ADDENDUM NO. 6
WATER SYSTEM IMPROVEMENTS
CONTRACT 18-01
GREENWAY BOULEVARD AND BACK VALLEY ROAD WATER LINE EXTENSIONS
CONTRACT 18-02
INDUSTRIAL PARK 500,000 GALLON ELEVATED WATER STORAGE TANK
DAYTON, TENNESSEE
WAUFORD PROJECT NO. 4630

Date of Addendum: August 22, 2019

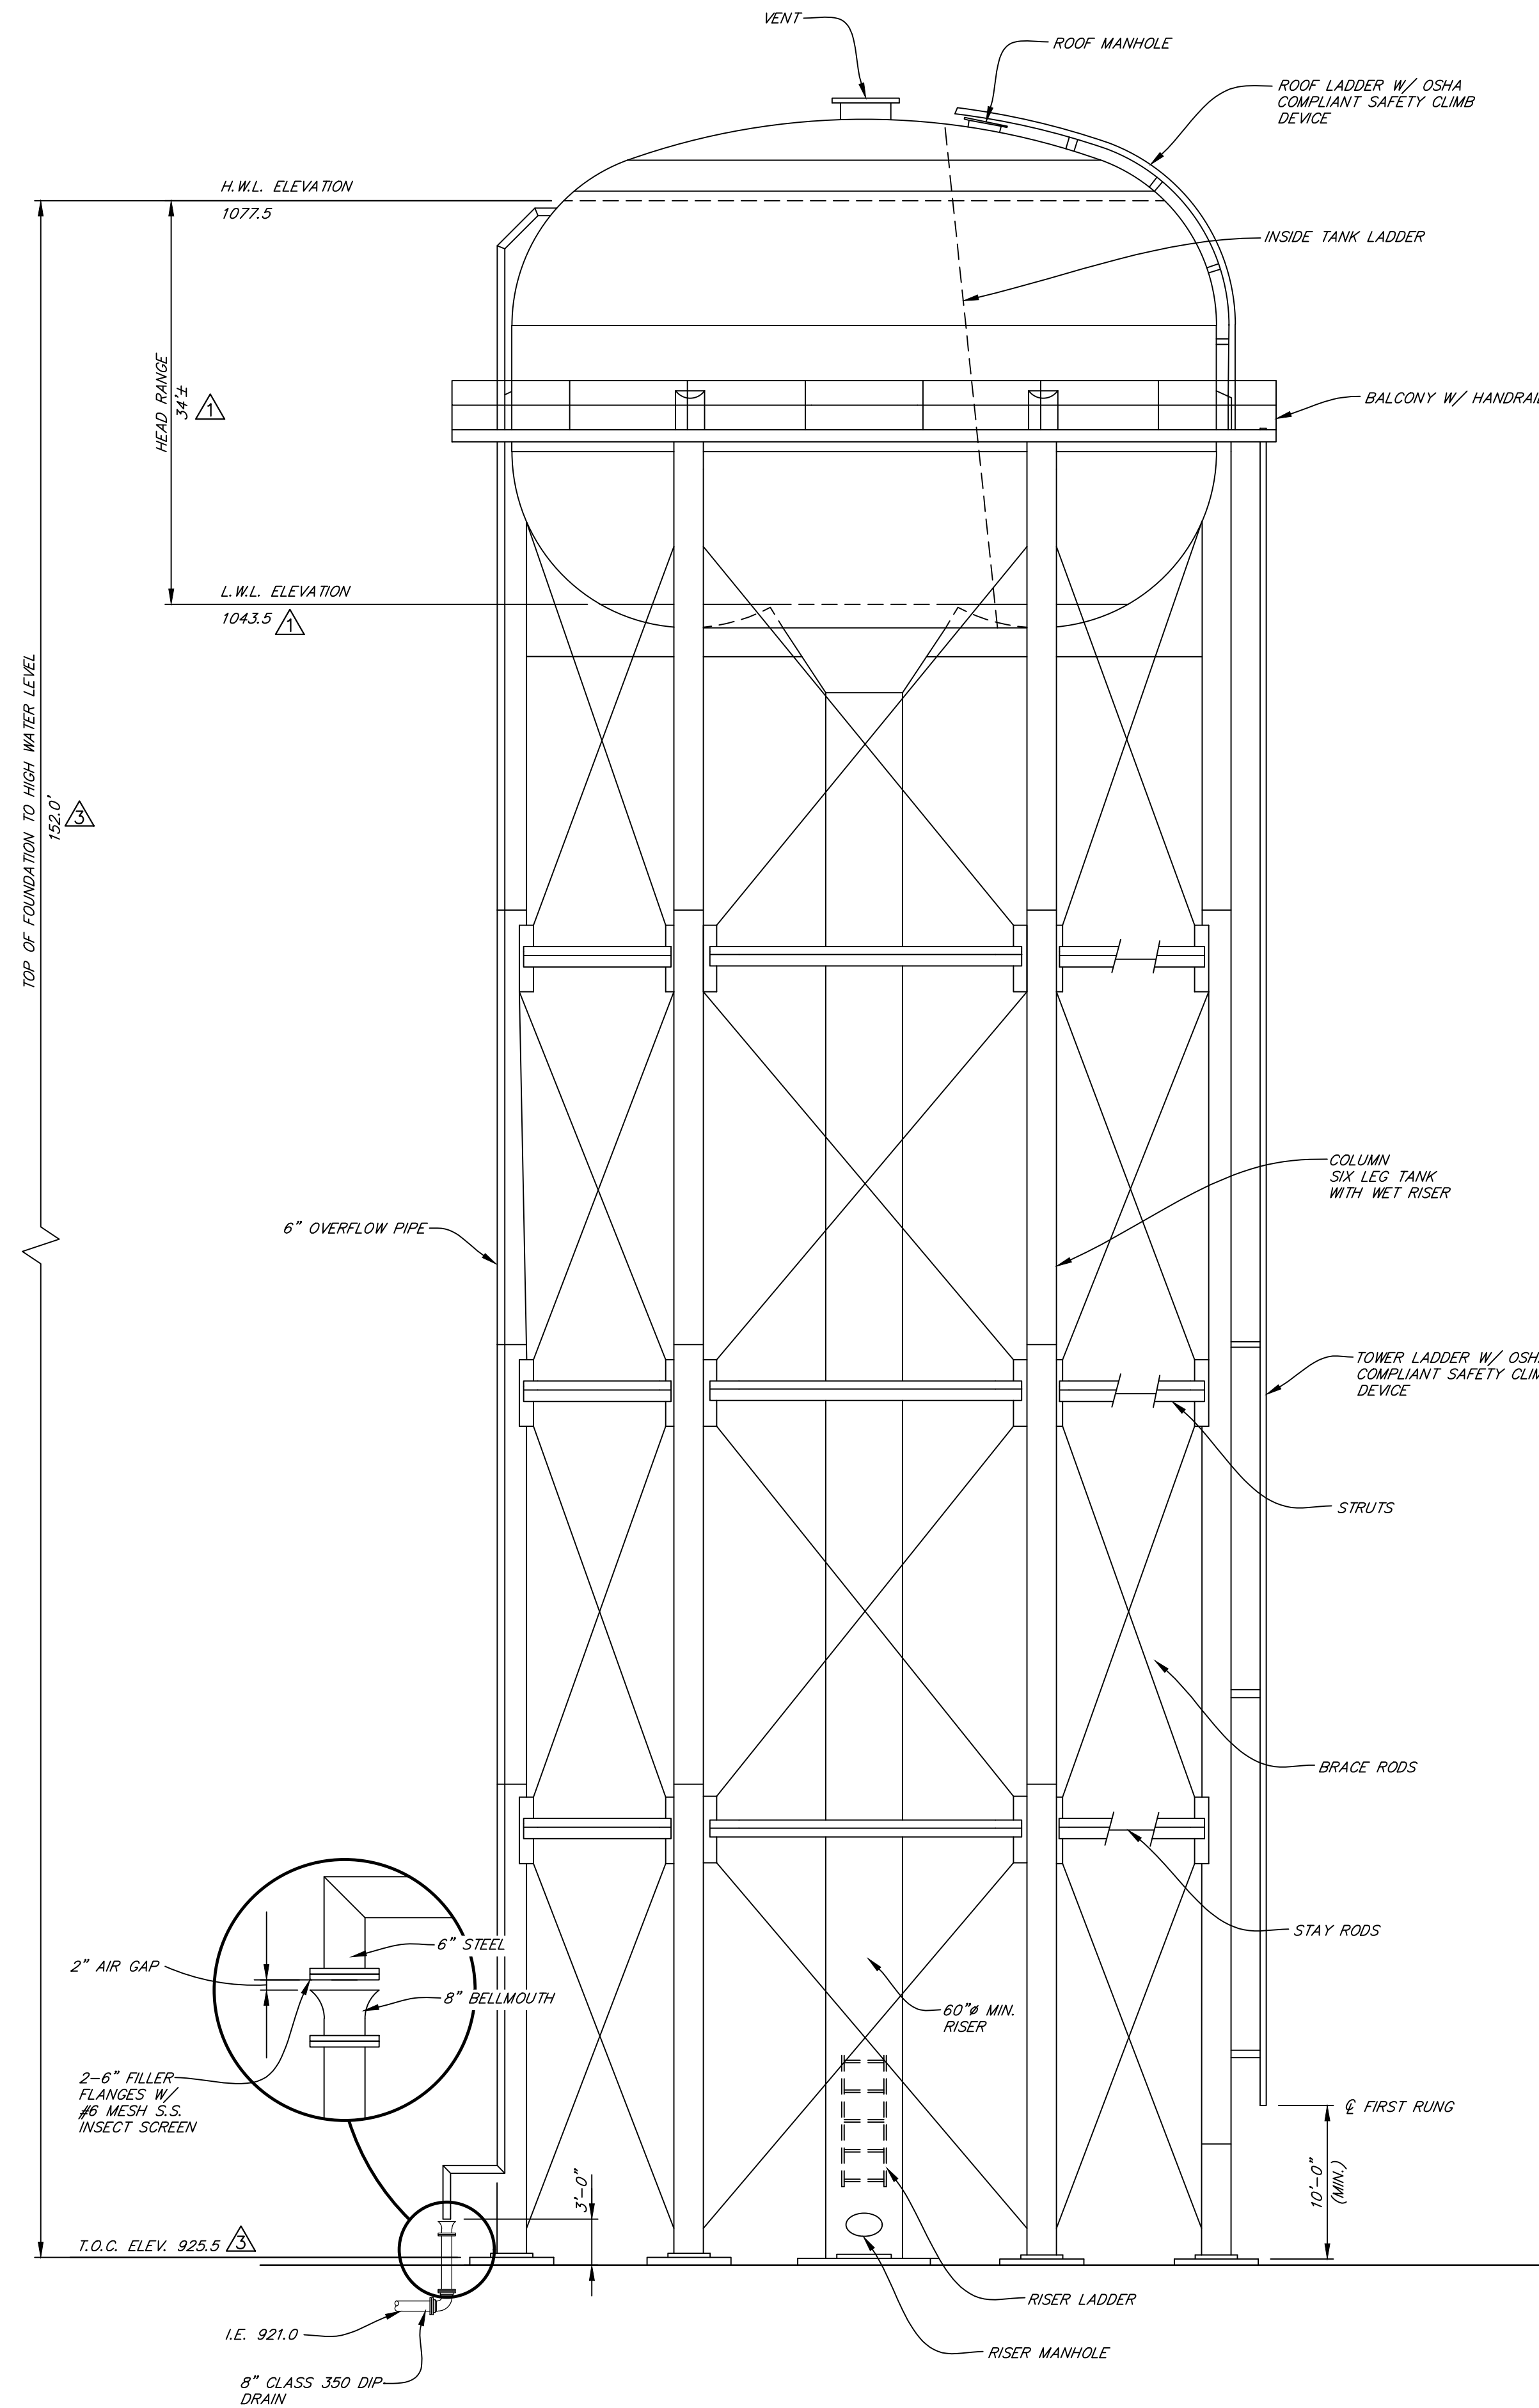
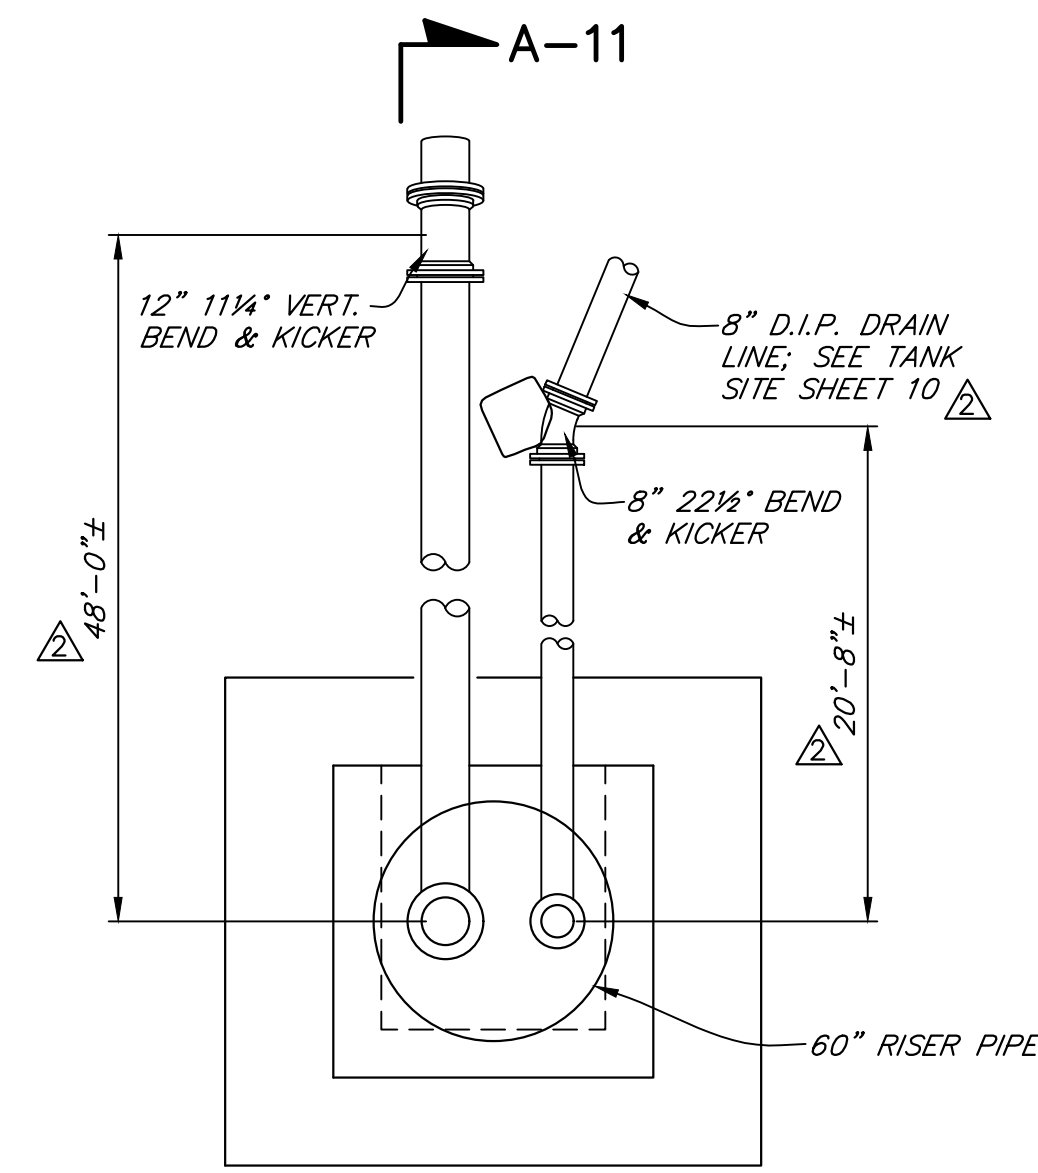
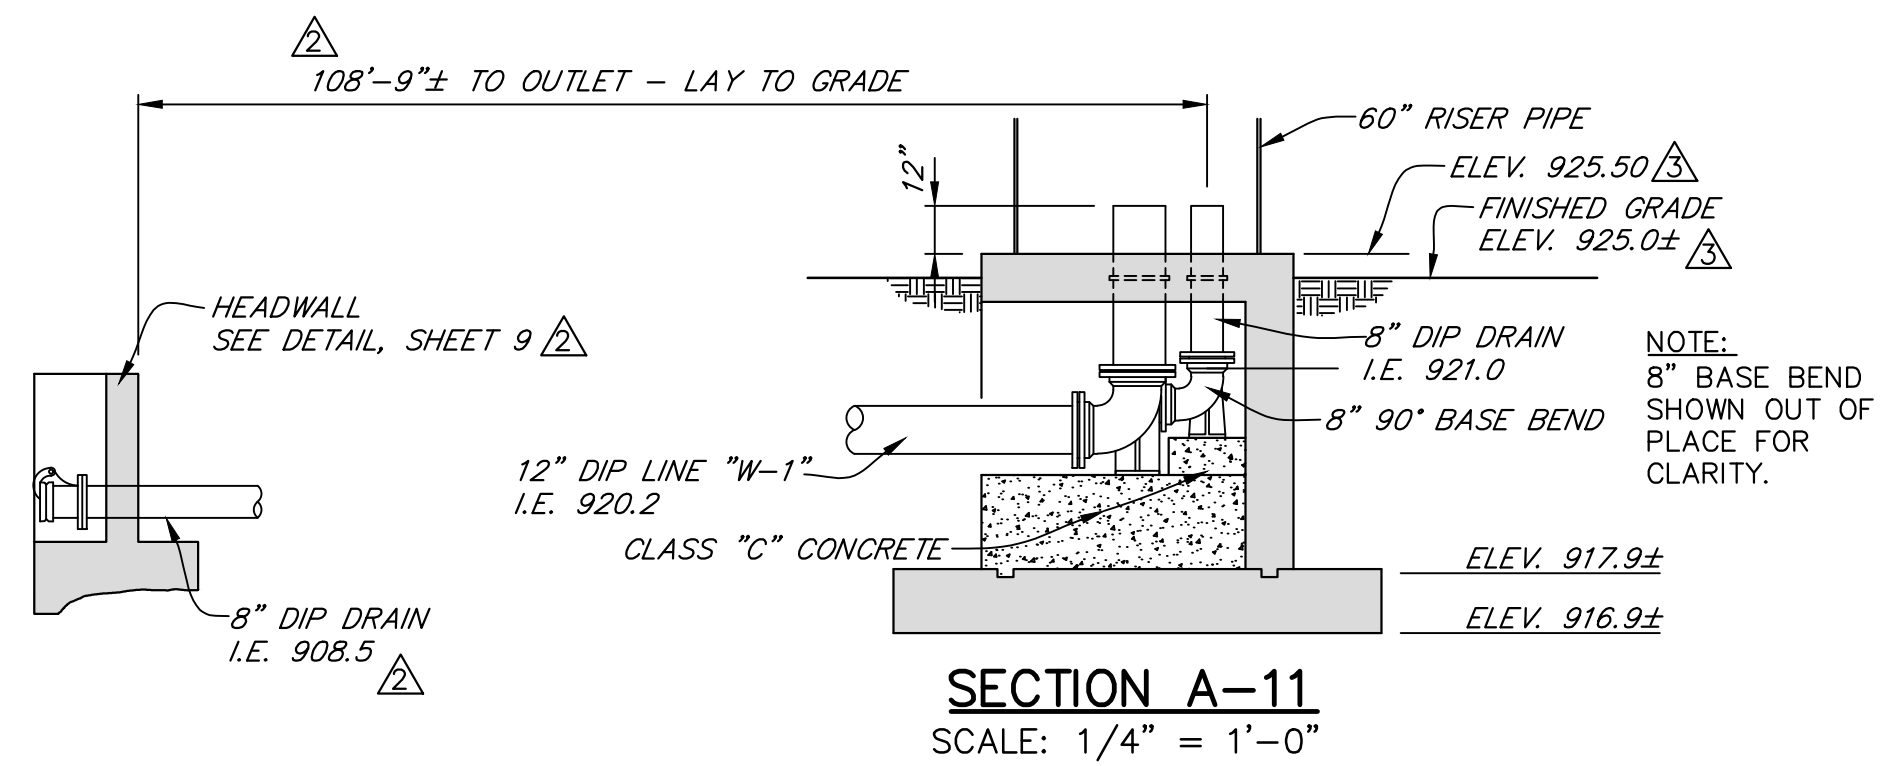
1. Plans, Sheet 11:

Revise as shown on attached Plans, Sheet 11.
